**United States Environmental Protection Agency
One Congress Street, Suite 1100
Boston, MA 02114-2023**

Re: Conditional Approval of General Electric's October 30, 2006 submittal titled Groundwater Management Area 1, *Evaluation of Additional Recovery Measures and Proposal to Install LNAPL Recovery Well – 60s Complex*, GE-Pittsfield/Housatonic River Site

SITE PLAN

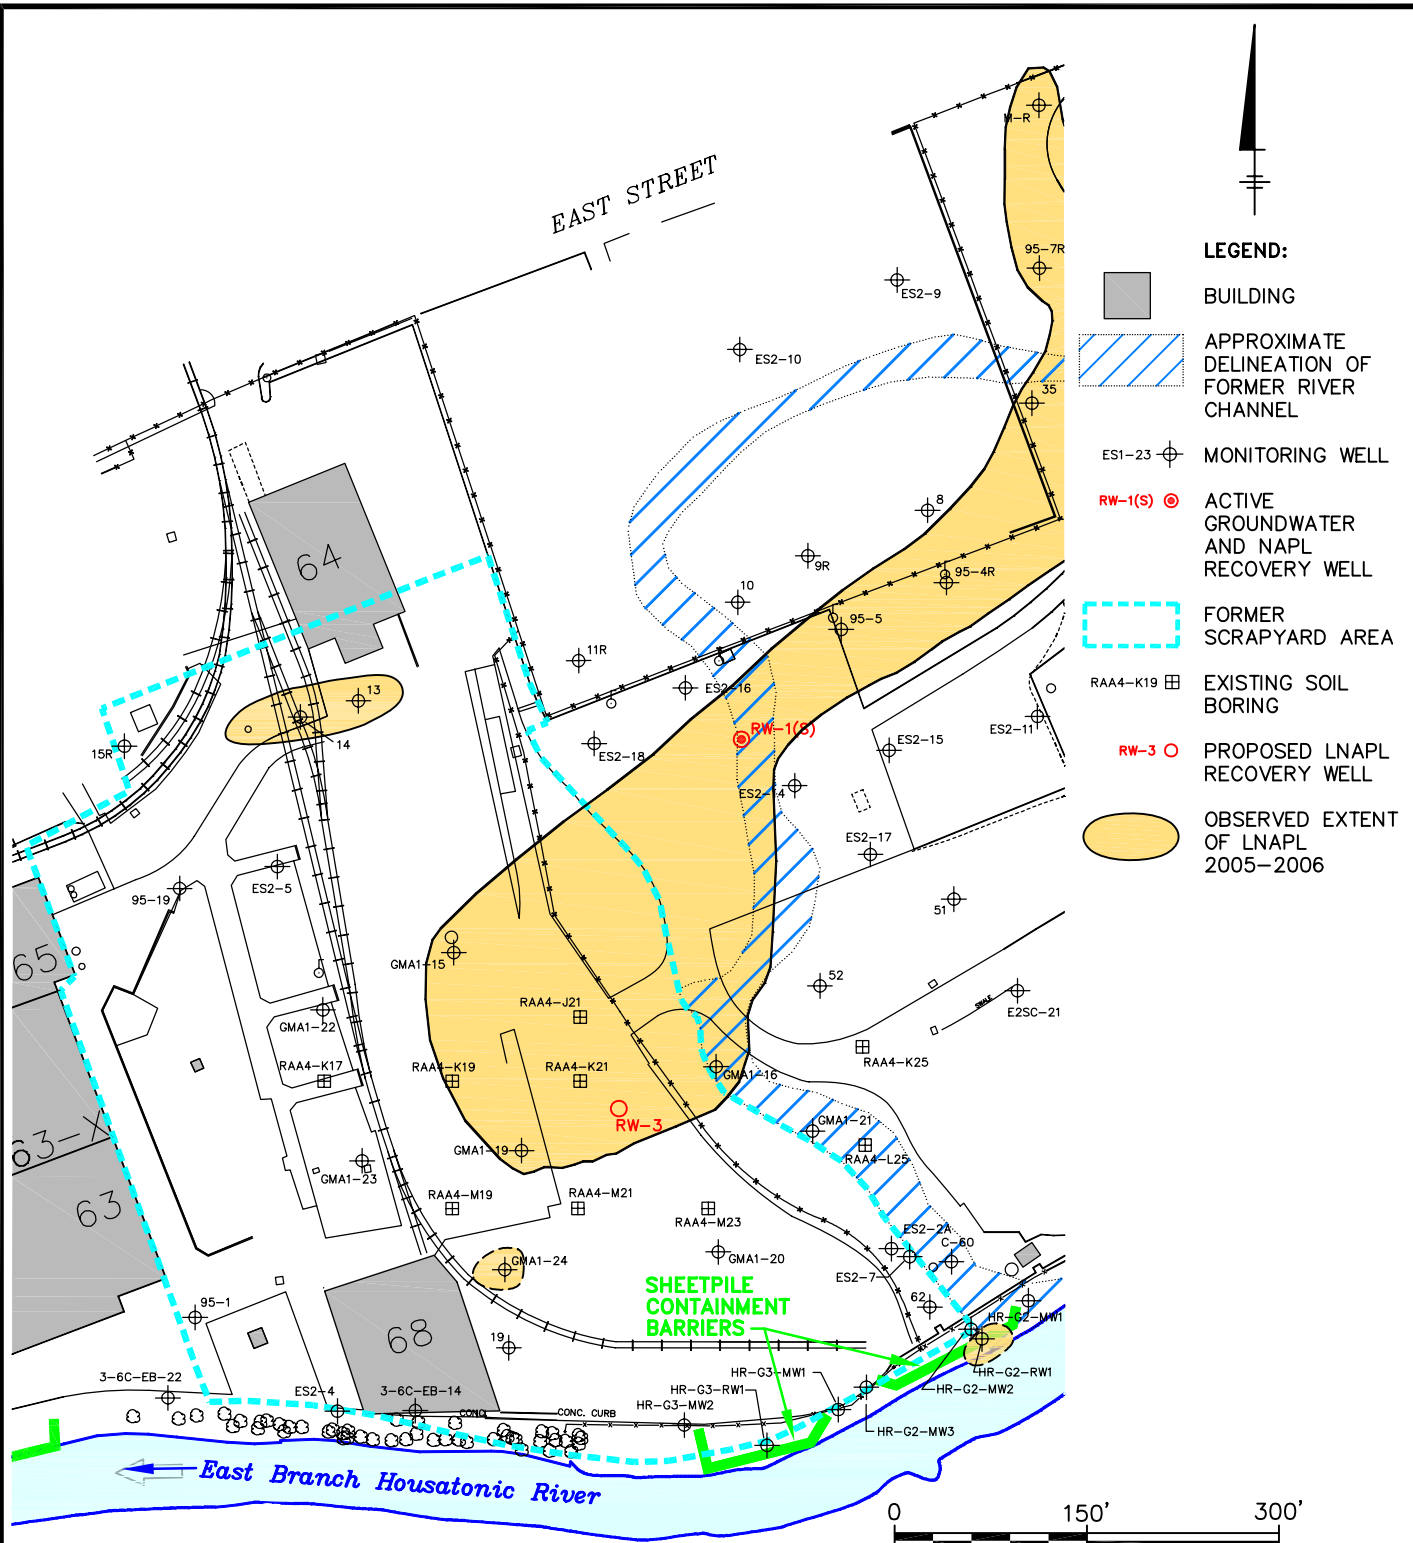
- Copies of Figure 1 (BBL Site Plan) and Appendix A Figures 1 and 2 (Golder Associates, Particle Starting Locations, Spring and Fall) in the Submittal with 0.5-ft groundwater elevation contours;
- Well construction and design details, including the proposed gravel/sand pack around the well; and
- Design rationale detailing the choice of the recovery well location when considering the seemingly increased NAPL productivity as moving from location GMA1-16 toward GMA1-19 (based on Tables 2 and 3 of the submittal).

The figures and well schematic presenting the well construction and design details requested above are attached.
